Re: DA 2022/1089/1 16 Old Hume Highway, 40 and 42 Macquarie Avenue Camden

Demolition of existing dwellings, construction of 10 x 2 storey townhouse development and strata subdivision

DCP 4.6 sets out minimum setbacks in Figure 4-8: Multi Dwelling Housing Setbacks and PPOS:

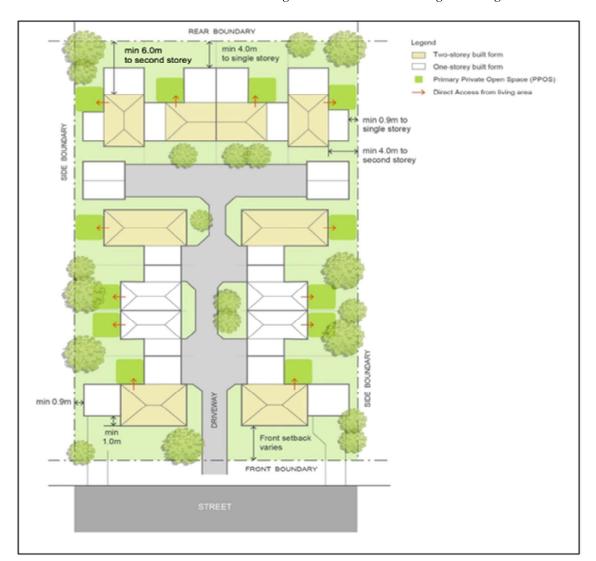
This DCP diagram also shows a layout that provides a greater degree of privacy and private garden amenity for future residents than this proposed development.

We consider that the setbacks are insufficient to retain amenity and privacy of adjoining properties, particularly 29A Murrandah Avenue and 18 Old Hume Highway as well as 40 Macquarie Avenue.

Currently 16 Old Hume Highway is at the rear of 29A Murrandah Ave and the proposed units 9 and 10 adjoin the rear of 29 A. DCP states that rear setback for upper floors is 6m but the architectural plans show a rear setback for the upper floor of only 4m at the boundary of 29A.

The privacy and amenity of 29A in particular is greatly compromised.

On examination of the architectural plans, we do not believe that setbacks are fully compliant with the DCP.
